TECHNICAL REPORT NO. 14

# ARIZONA CANAL DIVERSION CHANNEL SELECTION OF ROUGHNESS COEFFICIENTS FOR DESIGNING THE CONCRETE-LINED CHANNEL

September 1985

Committee on Channel Stabilization  
CORPS OF ENGINEERS, US ARMY

Figure 1

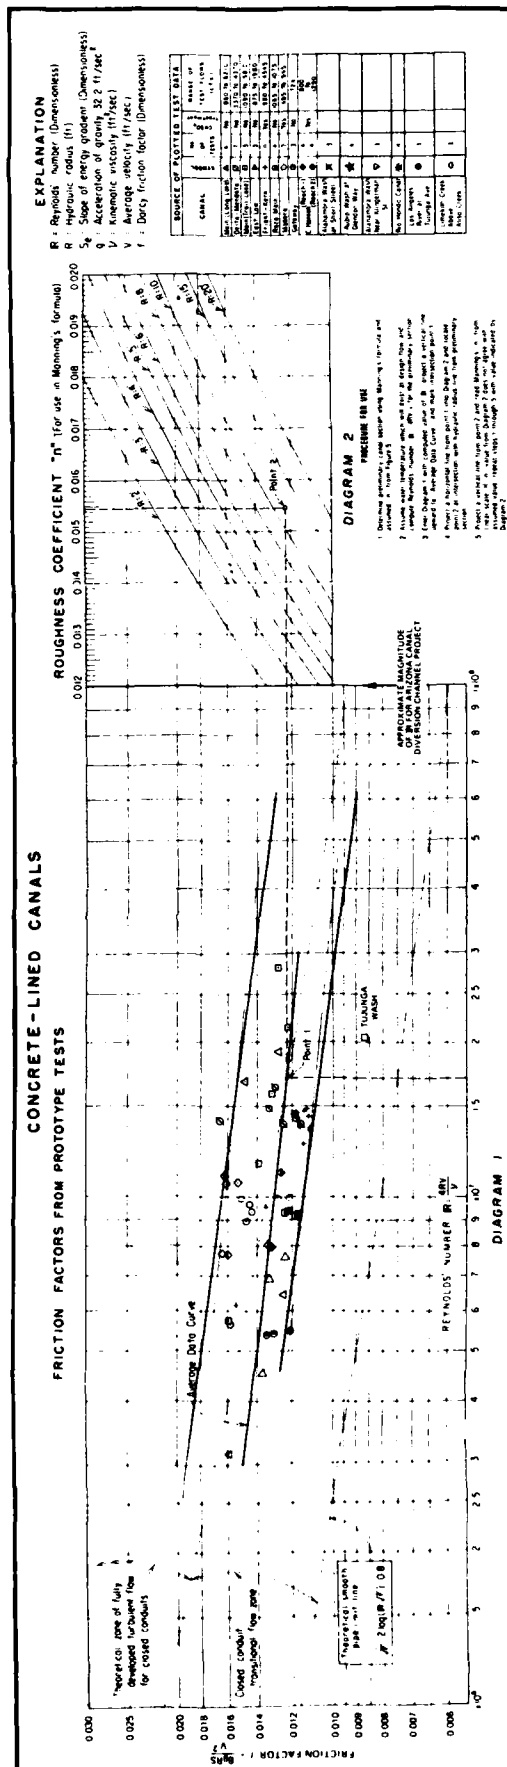
10. Most of the USBR data are for deep flow depths and low velocities, while the Corps data are for shallow flow depths and high velocities. The two sets of data seem more consistent when they are plotted. Figure 1 plots Darcy's  $f$  against Reynold's number as in the familiar Moody diagram. In Figure 1, both the Corps and the Bureau data scatter considerably; but they seem to form a consistent data set when the variations of hydraulic resistance with Reynold's number are taken into account.

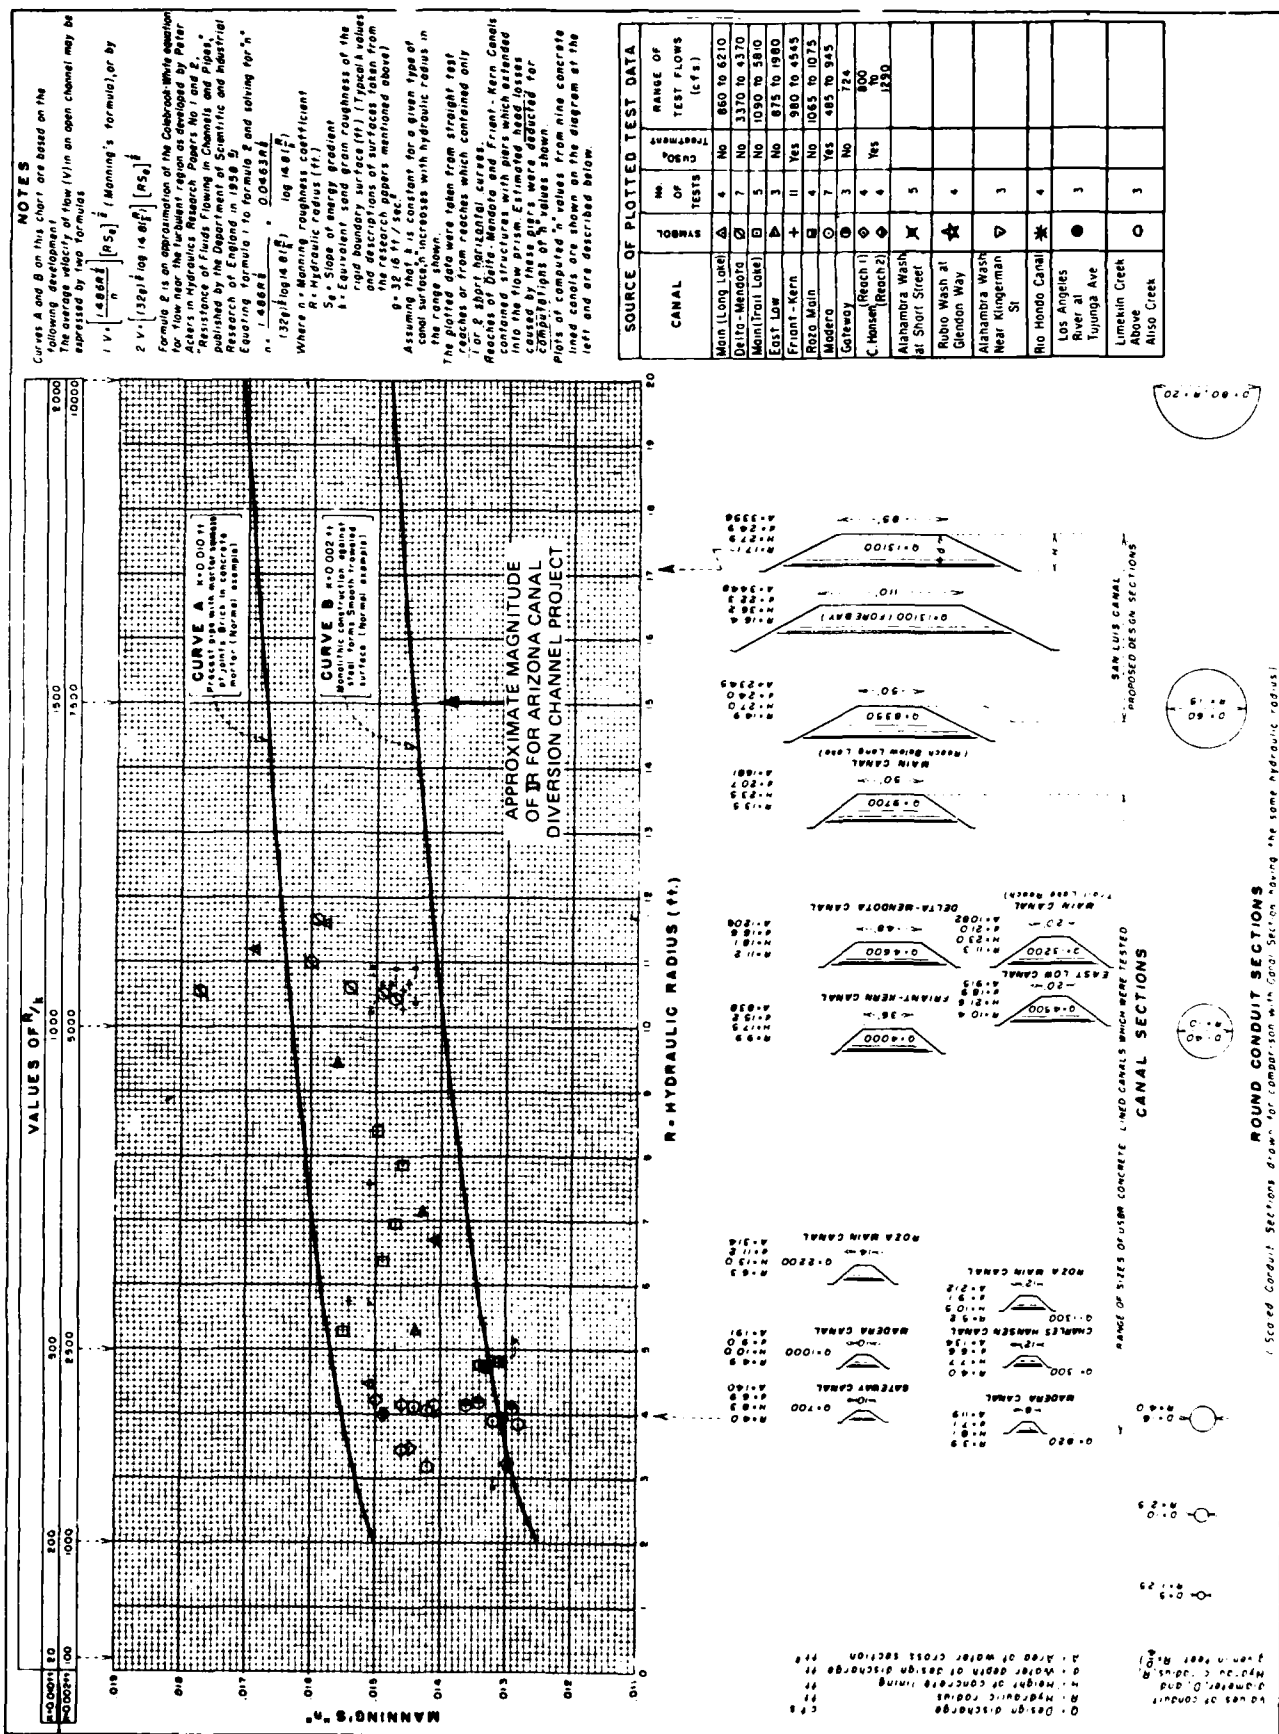
11. Figure 2 plots Manning's  $n$  against hydraulic radius for both the USBR and the Corps data. Again, the two data sets seem fairly consistent with the Corps data representing the lower end of the range of  $R$  (hydraulic radius). With respect to  $n$  values, data seem to scatter around the lower envelope of the USBR data. The vertical arrow at about 15 ft hydraulic radius denotes the approximate value for the Arizona Canal Diversion Channel. Figure 2 confirms that for the concrete surface at the site of the field measurements Manning's  $n$  tends to increase with hydraulic radius. This is in consonance with theory and laboratory measurements in which the Moody diagram is based. It means that where Manning's  $n$  is determined by measurement in a channel at a low flow depth, we should expect the  $n$  value to be greater at a deeper flow depth. Study of Figure 2 reveals that for the hydraulic radius  $R$  of around 15 ft a design  $n$  value of 0.014 might be acceptable; but it would be conservatively low.

12. In summary, the data supporting a design value of 0.014 are weak from several aspects; however, the data are equally weak in supporting another alternate value. It is the opinion of the Committee that an  $n$  value of 0.014 is adequate to design the Arizona Canal Diversion Channel for costing purposes. However, a varying value of  $n$  should be determined and used for detailed design of individual reaches of the channel.
